PART 1 - ADDENDUM

1.1.1. This Addendum is issued to provide for modifications and/or clarifications during Bidding and forms part of Bid and Contract Documents for above Project.

3 A100 LEVEL 03 - FIRE LIFE SAFETY
1 : 200 Ref: 3/ A008

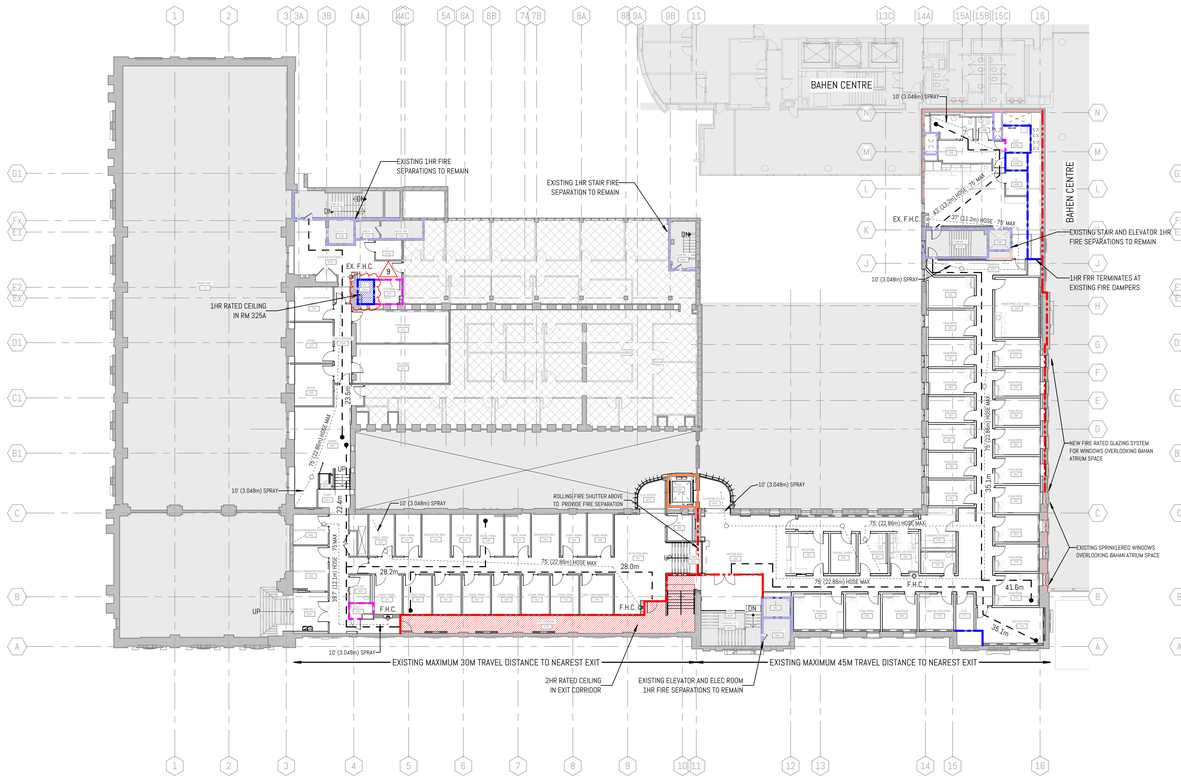
4.1.1.1. Added 1-hr fire rated ceiling to Elec 325A room.

SHEET NO. : **TM-0.8**
REV : **2**

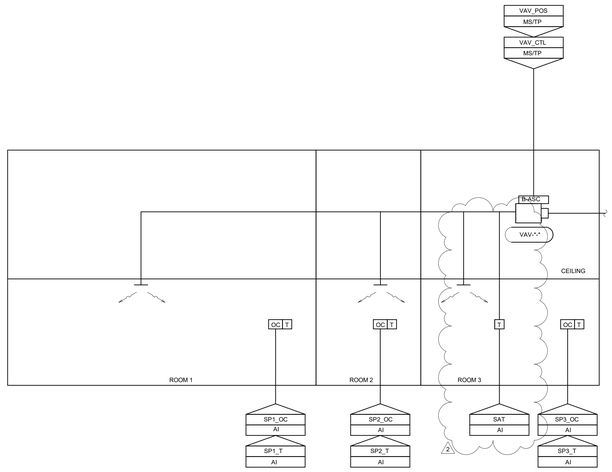
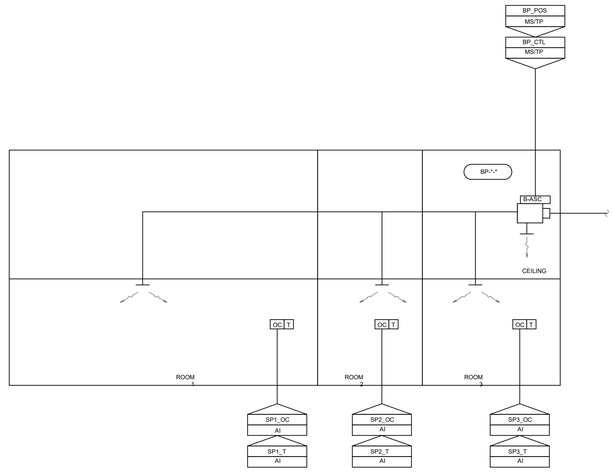
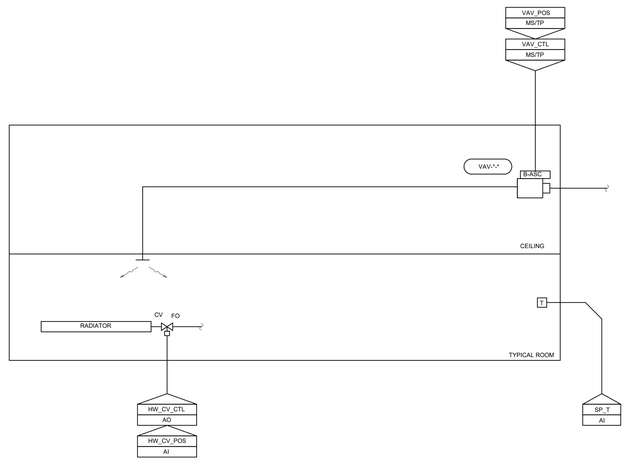
1.1.1 Revised controls diagrams and sequences as indicated on drawing.

SHEET NO : **TM-0.9**
REV : **2**

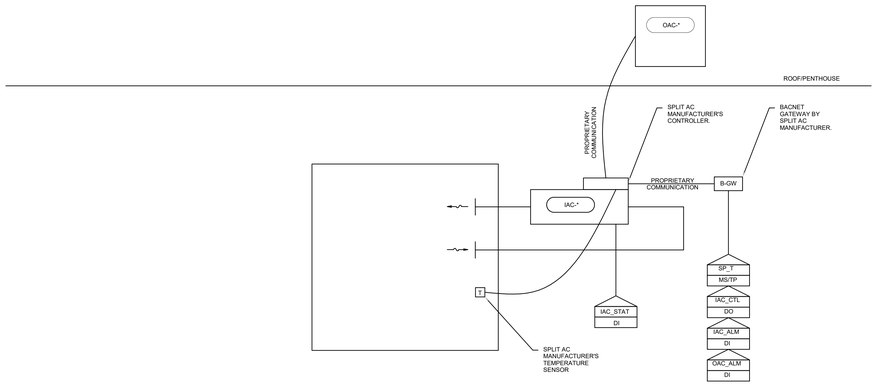
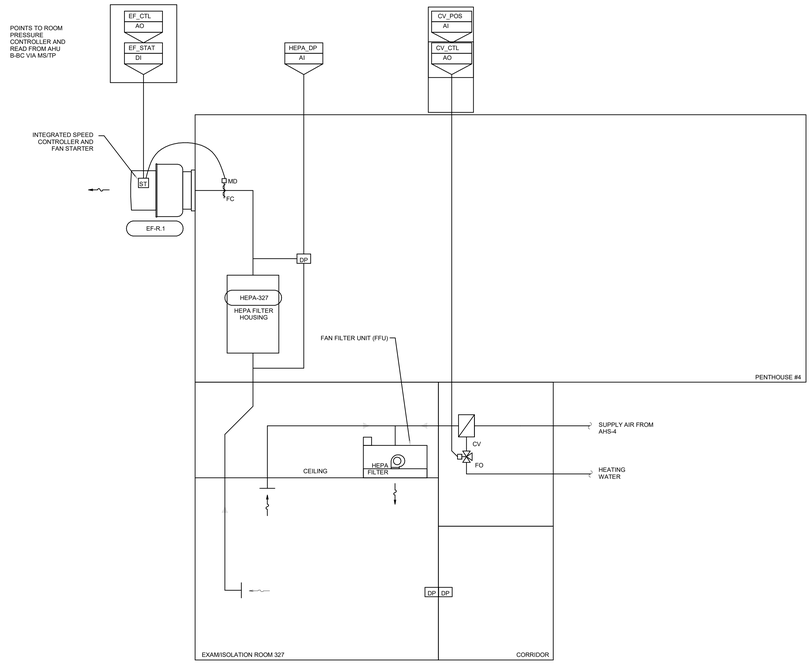
1.2.1 Revised controls diagrams and sequences as indicated on drawing.

SHEET NO : **TM-R.3**

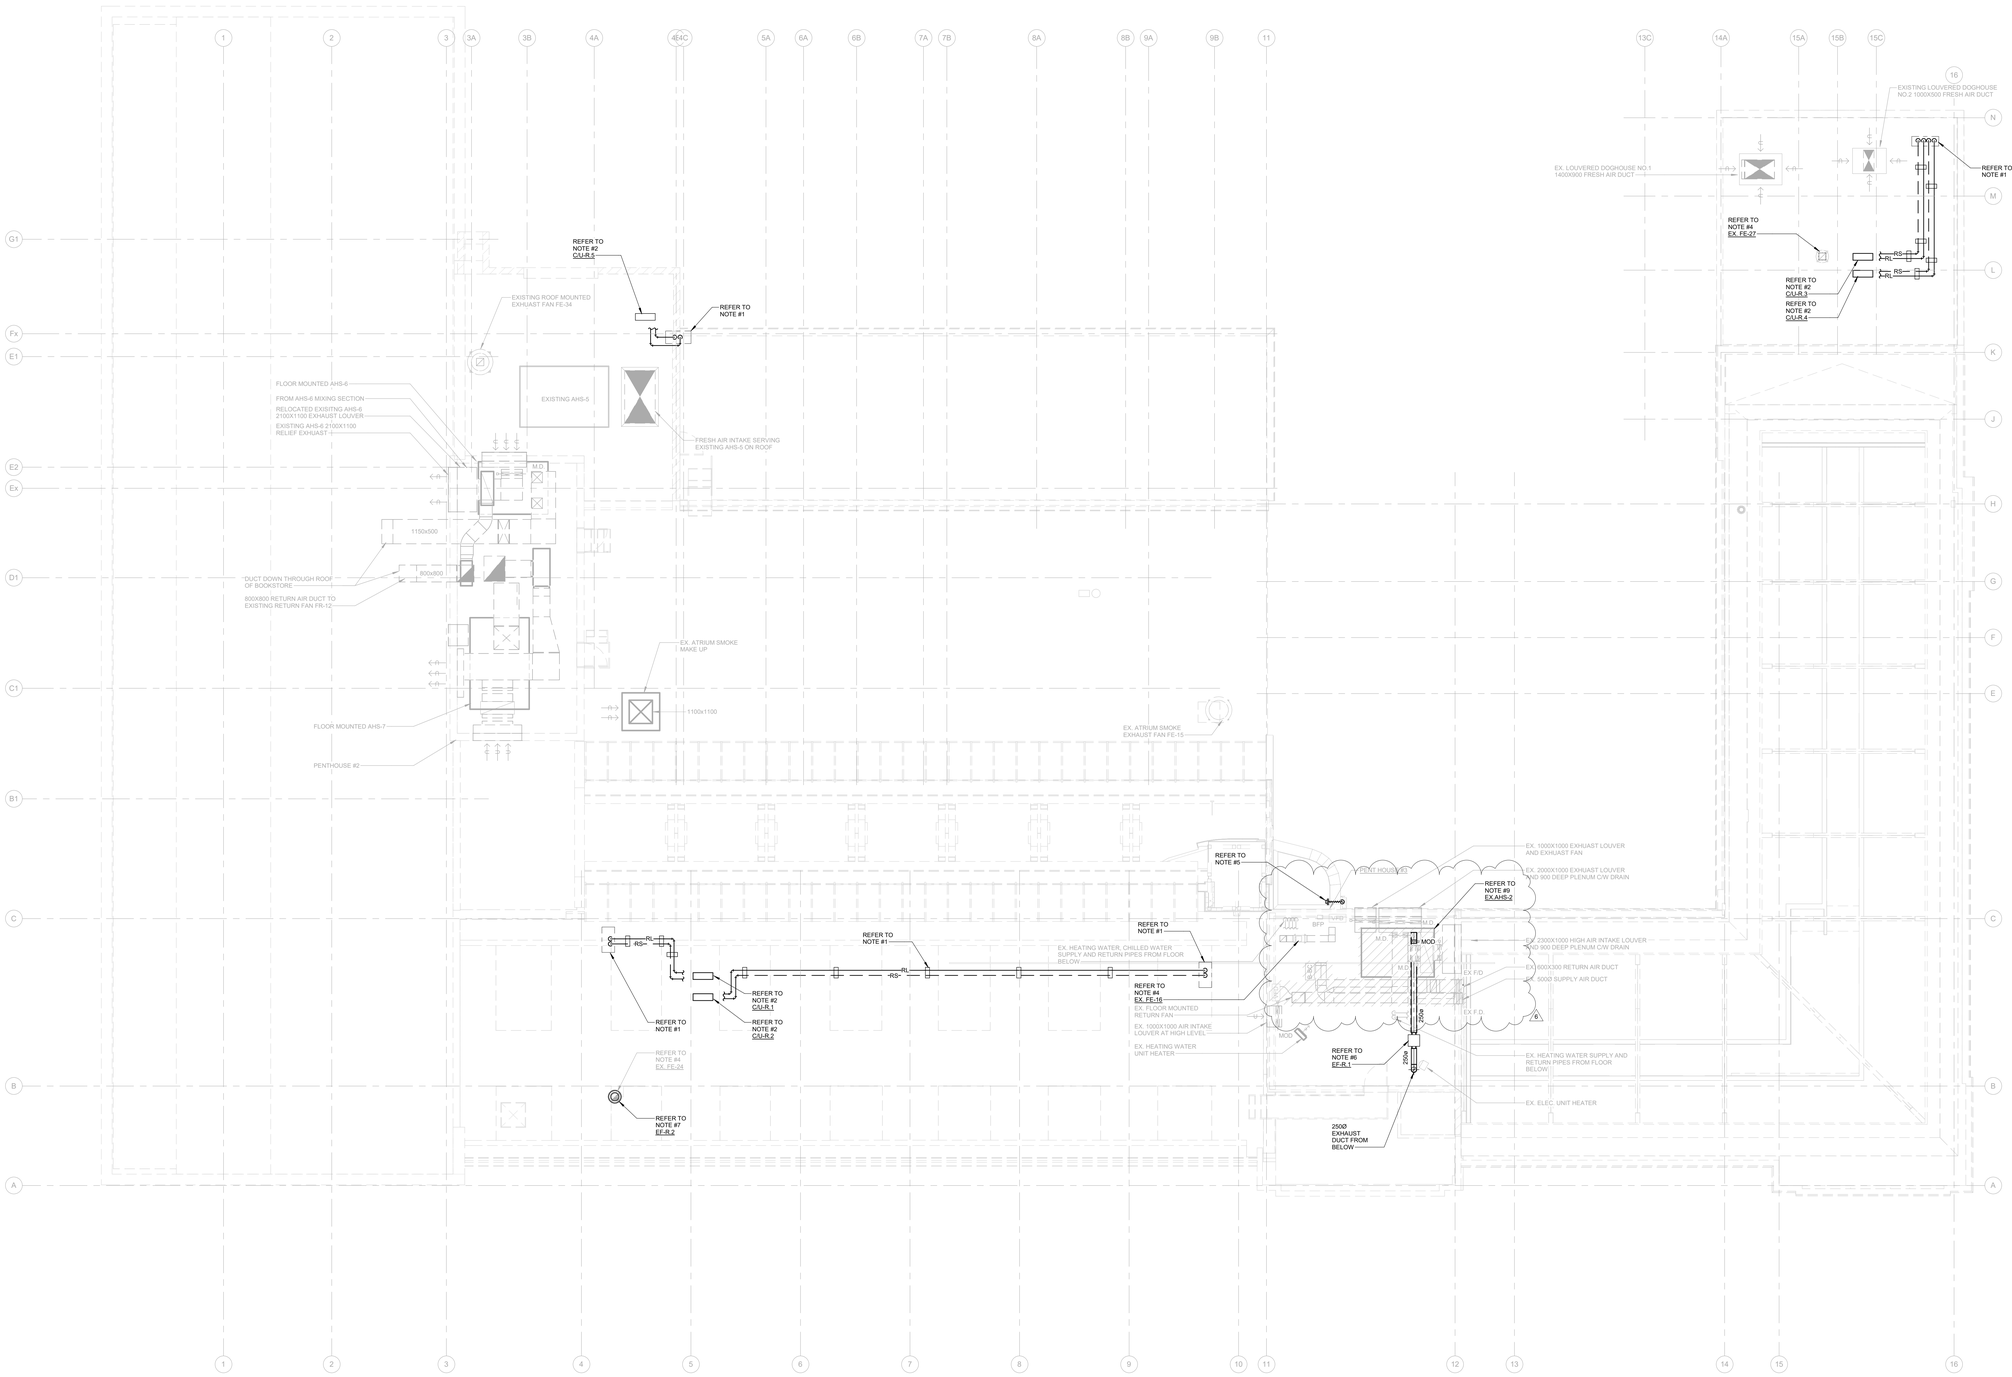
1.3.1 Removed existing AHS-2 as indicated on drawing.

1.3.2 Added Drawing Note #9.
